Magnolia Public Schools

Ad-Hoc (Facility) Committee Meeting

Approval of Change Order Requests by Oltmans Construction Co. for MSA-1

Ad Hoc Committee Agenda Item #:	II A – Action Item
Date:	December 4, 2019
To:	Magnolia Educational & Research Foundation dba Magnolia Public Schools (“ MPS ”) Ad Hoc Committee (the “ Committee ”)
From:	Alfredo Rubalcava, CEO & Superintendent
Staff Lead:	Patrick Ontiveros, General Counsel & Director of Facilities
RE:	MSA-1 Change Order Requests

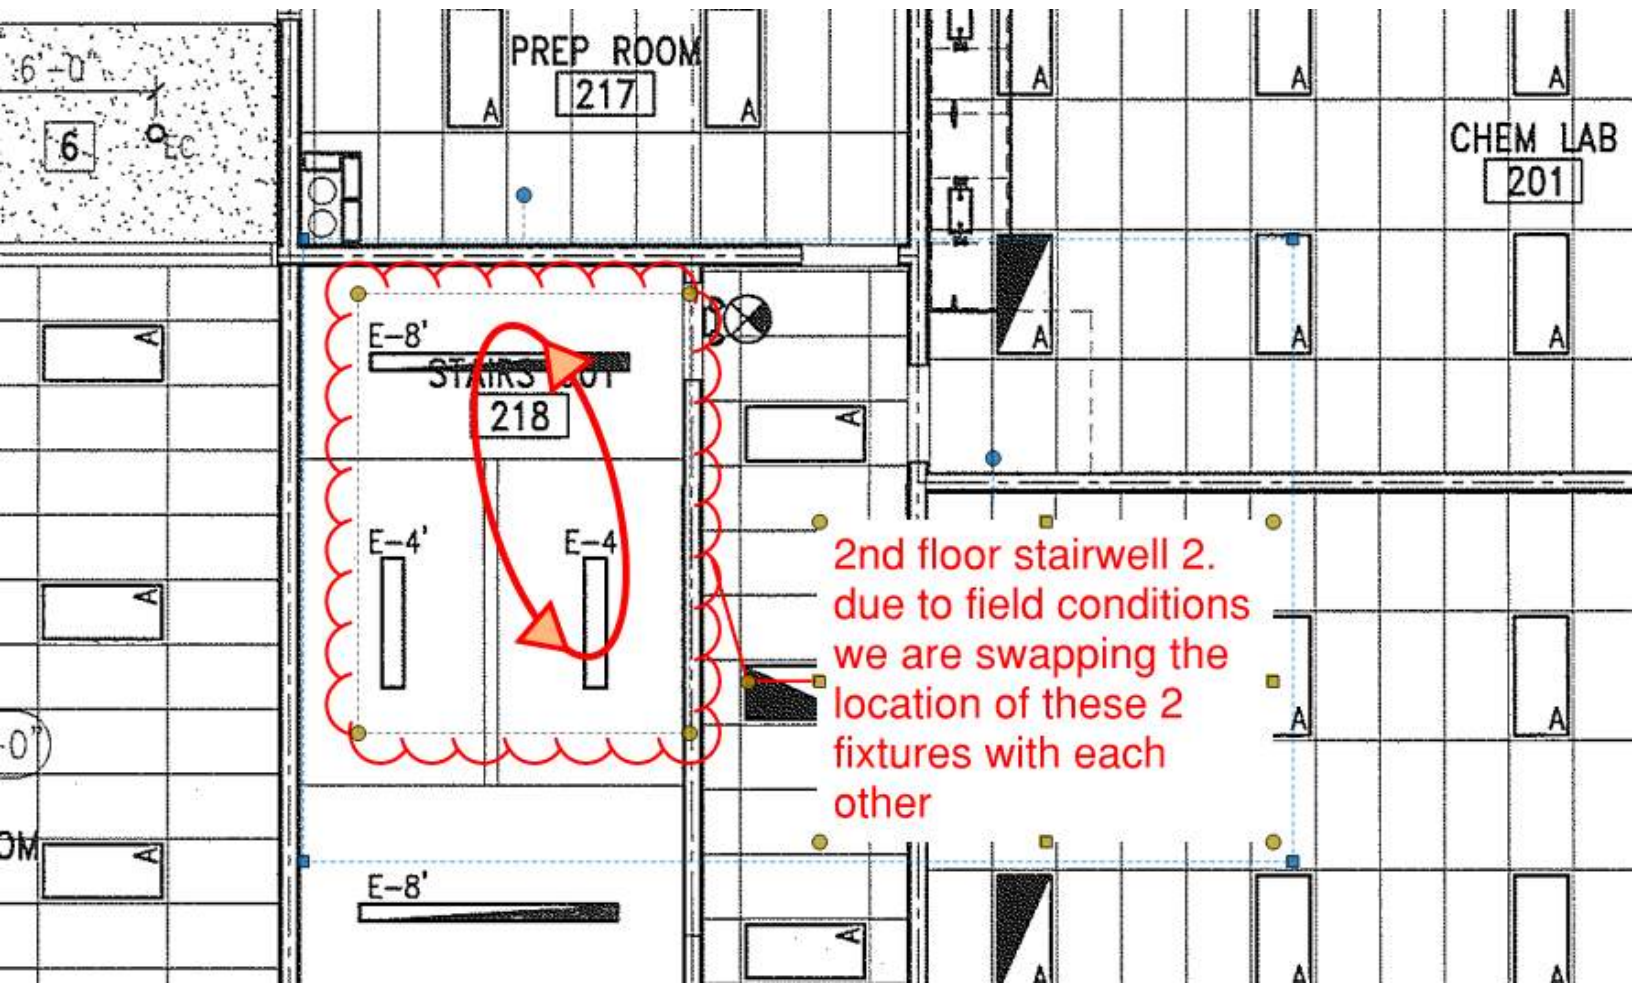
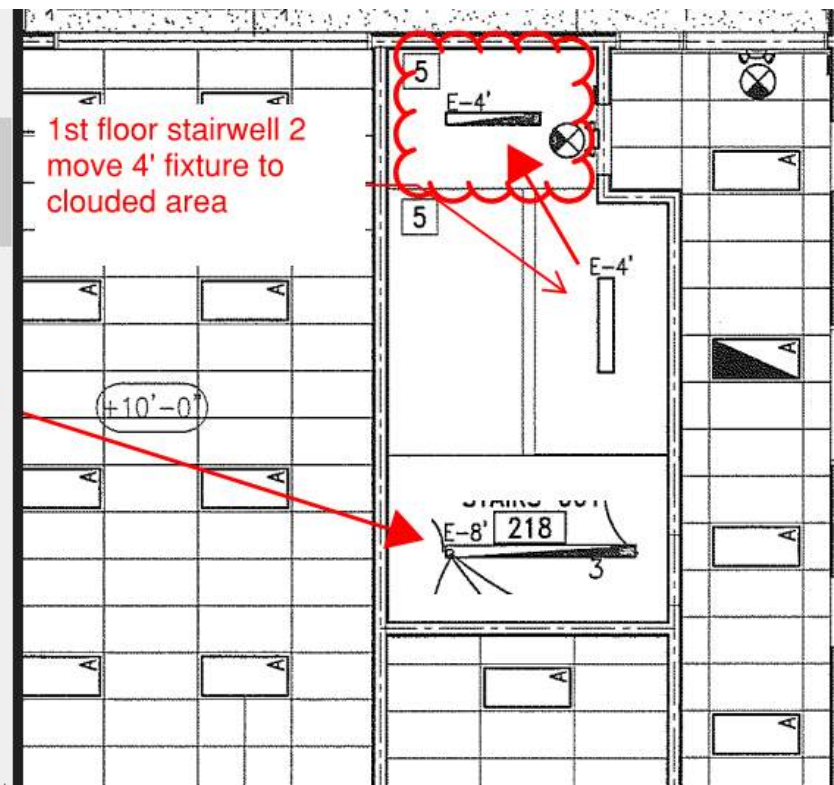
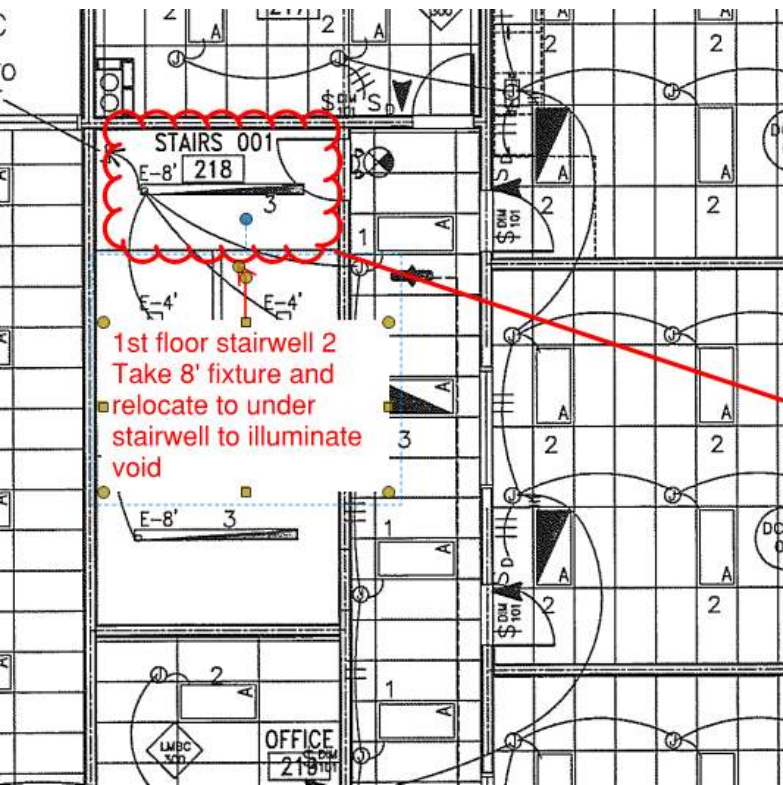
Please provide mounting clarification for the E4 fixtures in the stairwells (sheets E3.1 & E3.2). The prints show the fixtures to be mounted on the underside of the steel stairs. Attached is a photo showing the field conditions that are typical for both stairwells. In the photo you can see the all Steel Stairs are surrounded by Beams and Gluelams.

Co-Author RFI Number: 6/S7.1 Strap

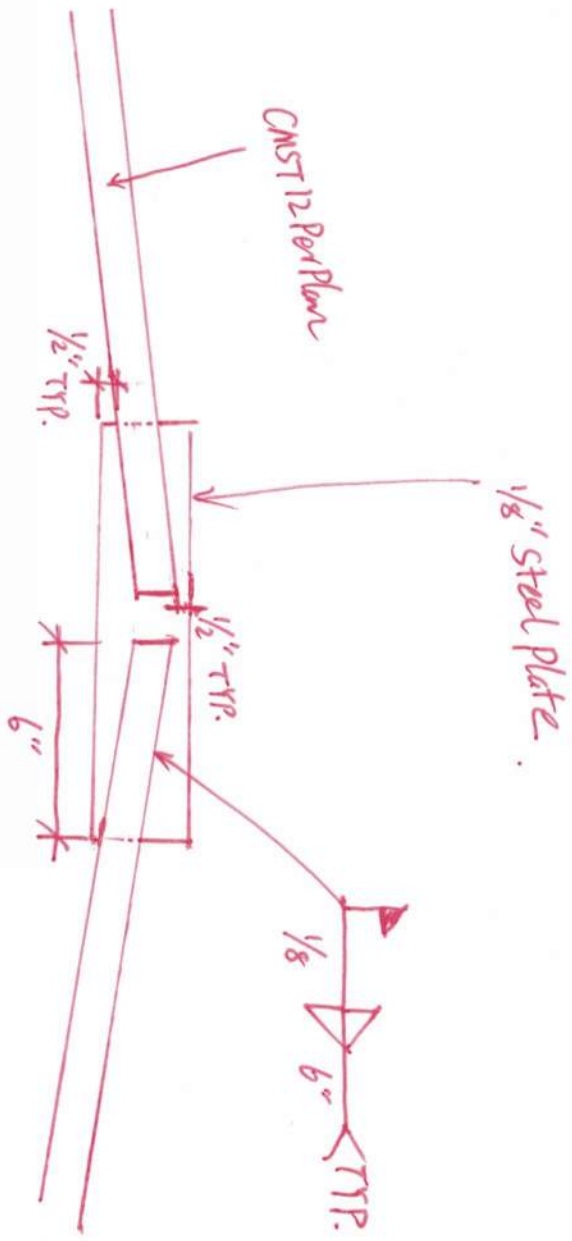
Sheet S 7.1 detail 6 calls out for a CSMT 12 strap, see attachment, this strap cannot be installed on the side of the top plate due to the required roof pitch. The strap cannot be bent to match the pitch. Please advise.

Splice at the strap turning point with 1/8" steel plate with 1/8" x 6" long welding at top and bottom of each strap end.
Please see the attached sketch.
